RAILROAD COMMISSION OF TEXAS

PROPOSAL FOR DECISION

OIL AND GAS DOCKET NO. 02-0284942

THE APPLICATION OF PIONEER NATURAL RES. USA, INC., TO CONSIDER
PERMANENT GAS WELL CLASSIFICATION FOR ALL WELLS ON THE RIDLEY 01
UNIT, SUGARKANE (EAGLE FORD) FIELD, KARNES COUNTY, TEXAS

Pioneer Exh. No. 19

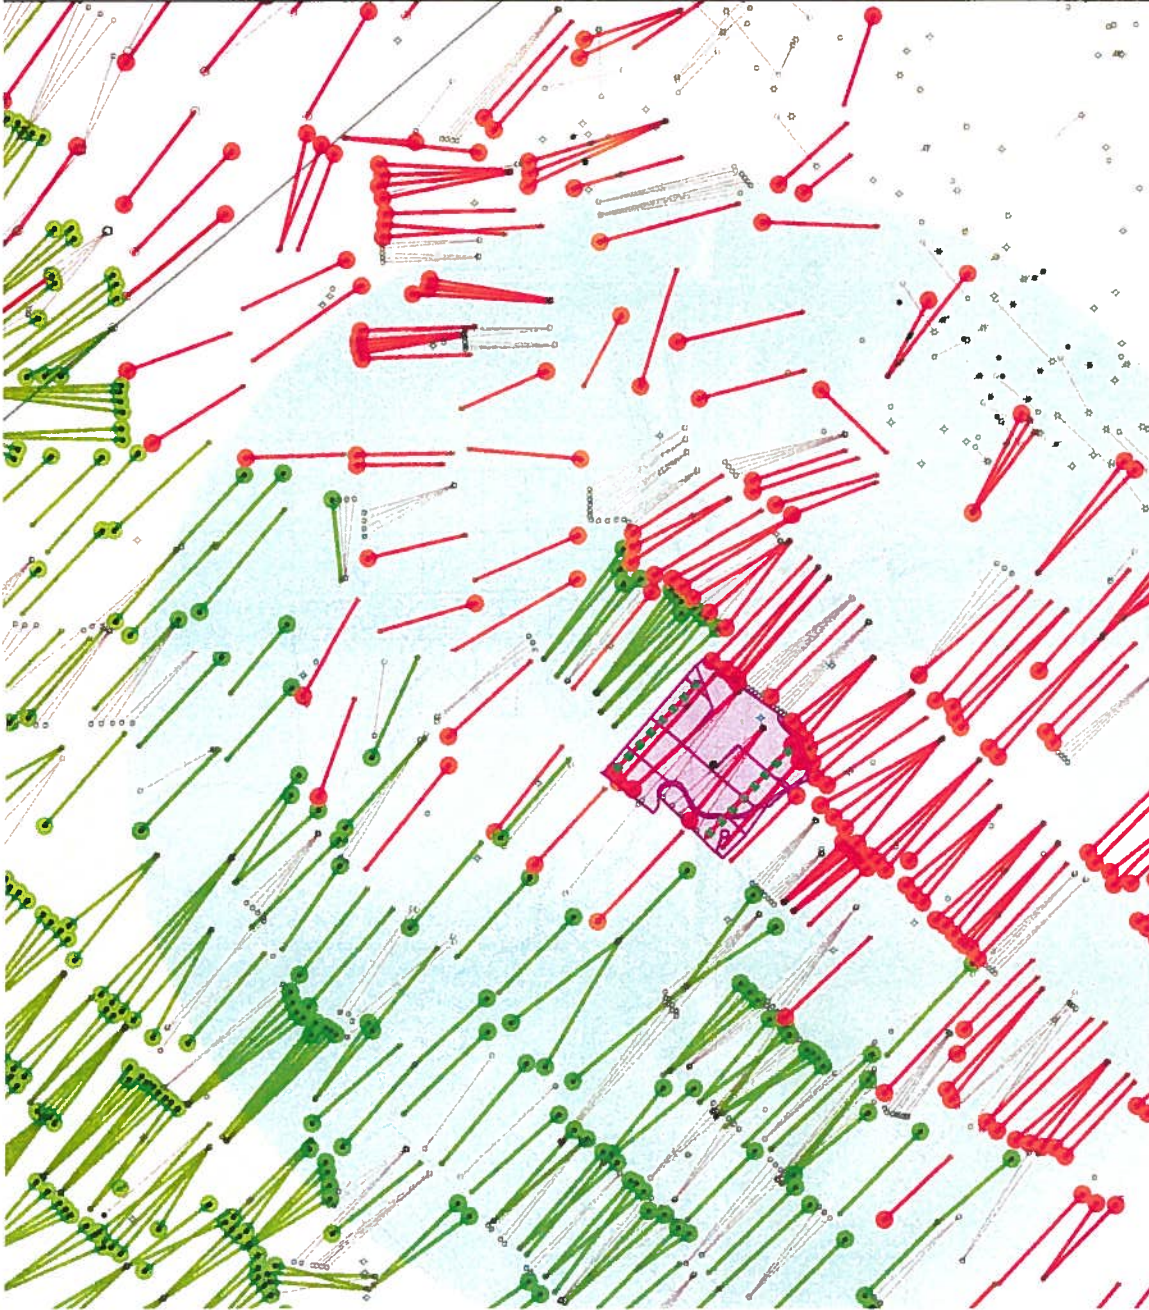
Examiners' Notes: The Ridley 01 Unit is in the transition zone from gas (southeast) to oil (northwest). Gas wells are in red, and oil wells are in green. Wells that are outlined but not colored are permitted locations that have not been drilled, or have been drilled but completion reports have not been approved (which includes 7 of the 11 Ridley 01 Unit wells). On Exhibit 19 Pioneer has identified six wells on the Ridley Unit as gas wells. This is incorrect. The 2H and 4H wells have not been classified as gas wells. The 2H and 4H wells are shown by the Examiners with green dashed lines.

Pioneer Exh. No. 21

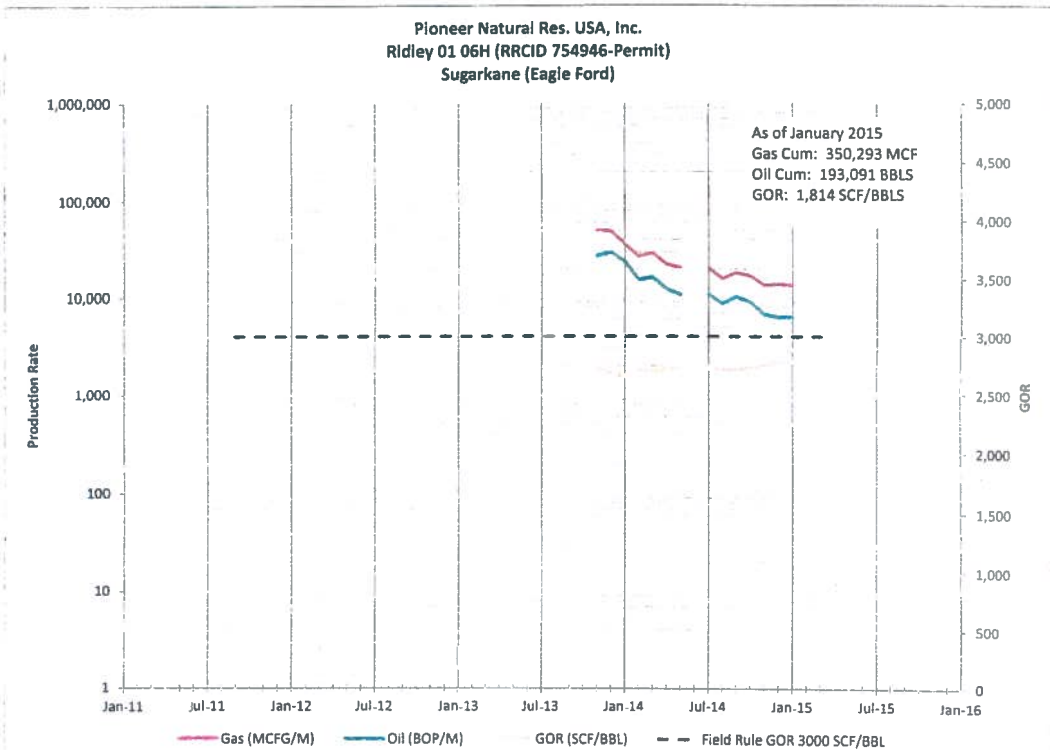
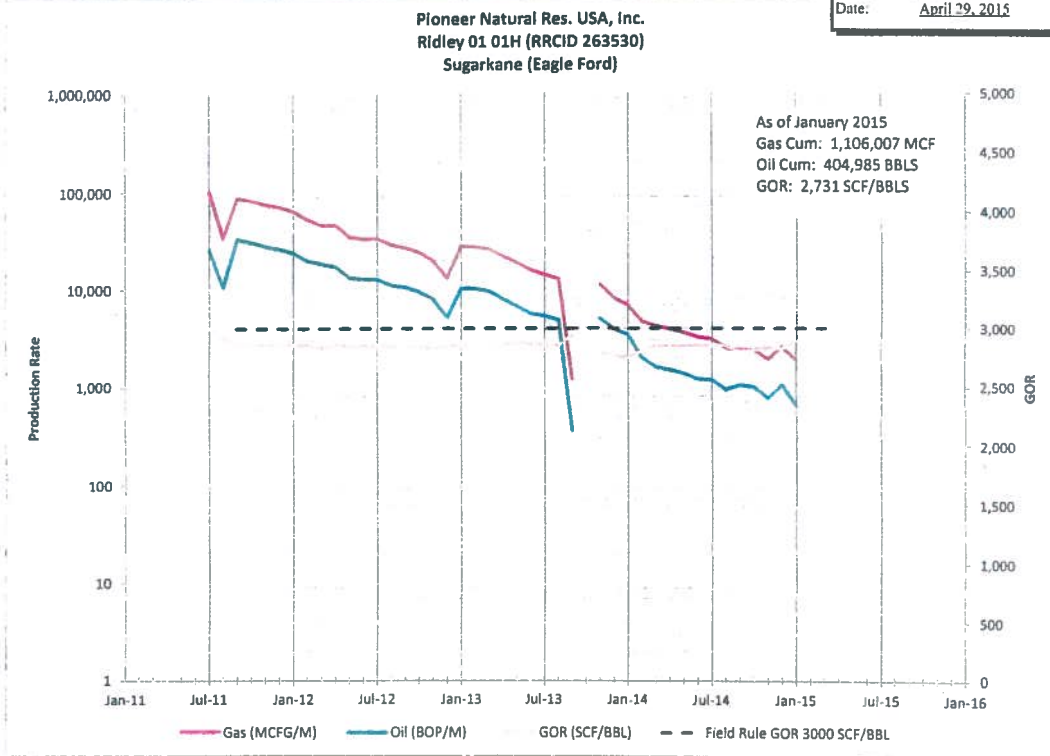
Examiner's Notes: Production history for Well Nos. 1H (top) and 6H (bottom). The black dashed line identifies the 3,000:1 gas-oil ratio (GOR) required for field rule classification as a gas well. For both wells (and all others on the unit portrayed on Exhibit no. 21) The individual well GORs remain below 3,000:1 for the producing history.

Pioneer Exh. No. 19

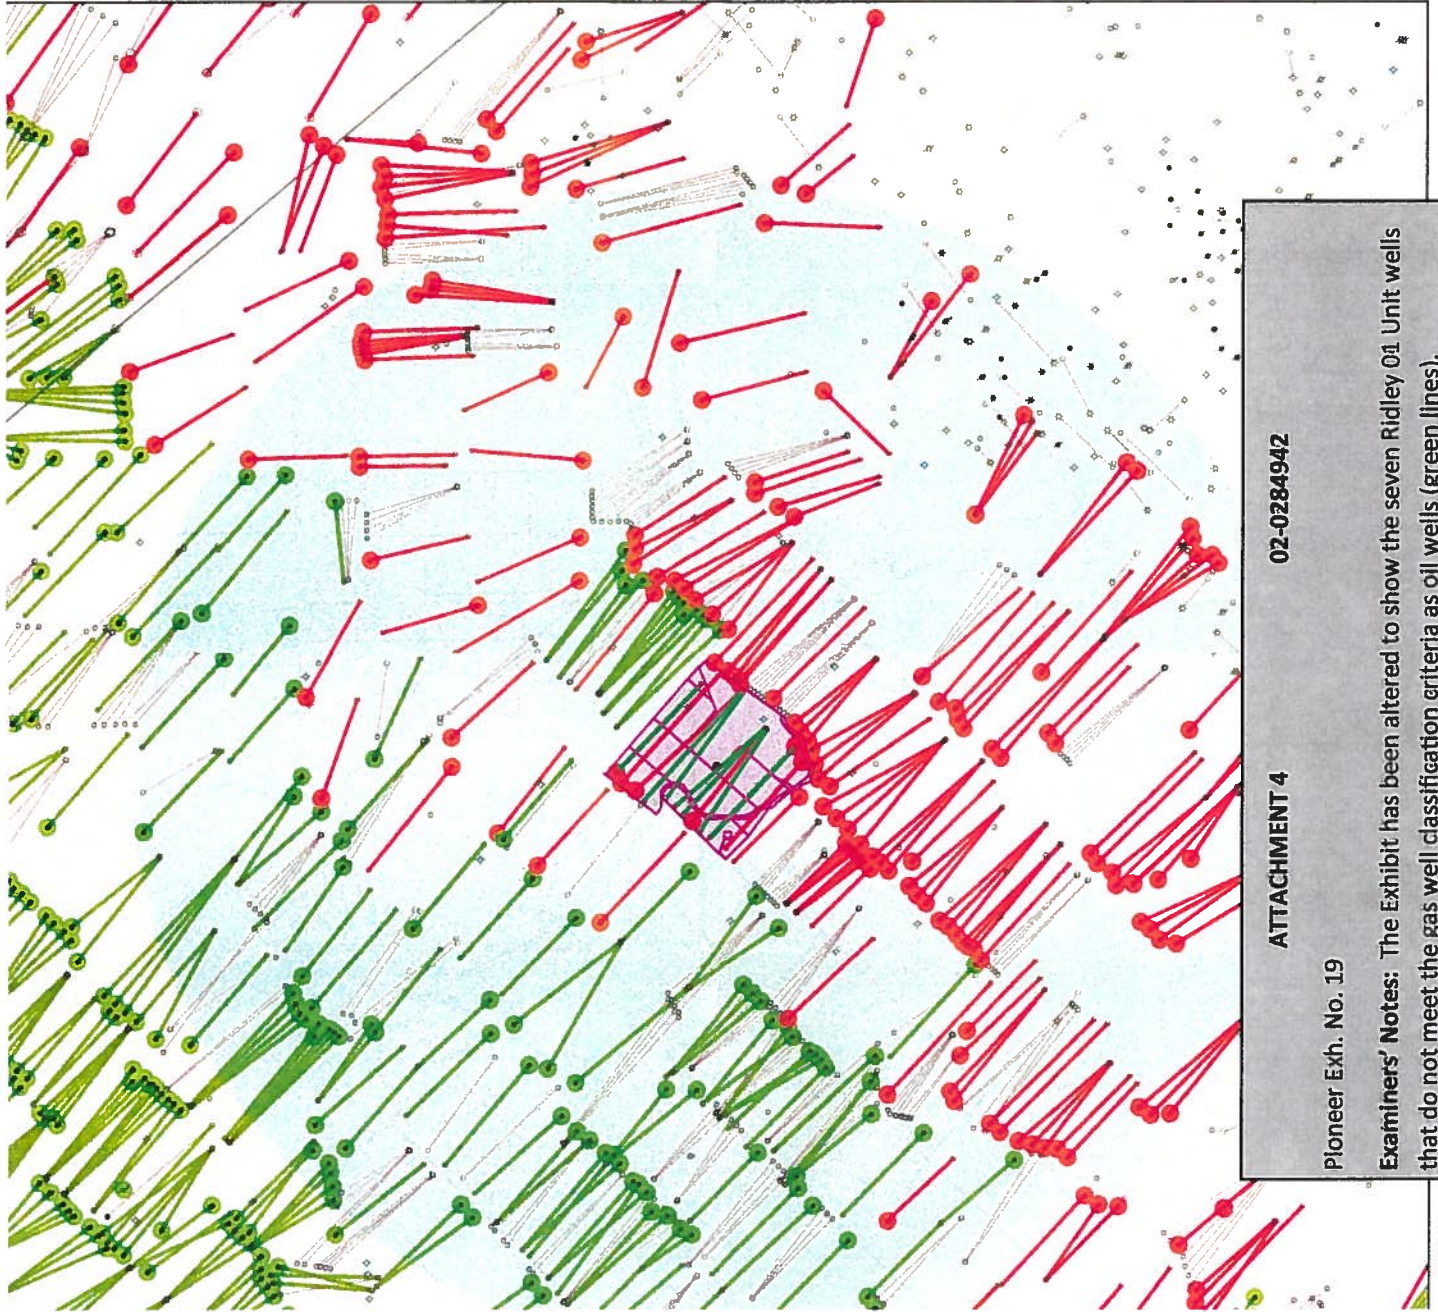
Examiners' Notes: The Exhibit has been altered to show the seven Ridley 01 Unit wells that do not meet the gas well classification criteria as oil wells (green lines).
